## Piston Pin Retaining Clip Change

### ▲ Models Affected

All 2.5 Consumer Hi-Performance Engines  
2.5 EFI Offshore Race  
2.5 EFI Drag  
S3000

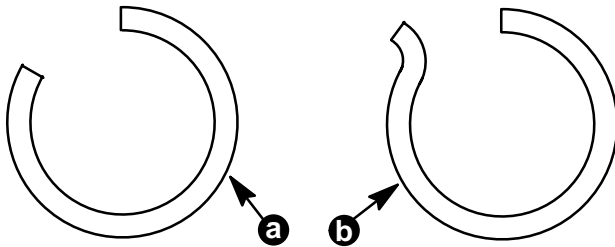
This new retaining clip can be used in pistons which have the notch for the bent end retaining clip, and can be used in conjunction with or to replace the old style bent end retaining clips.

The bent end retaining clips that required a notch in the piston cannot be used in new style pistons which do not have the notch.

a - New Retaining Clip P/N 53-821246-1

b - Old Retaining Clip P/N 53-821246
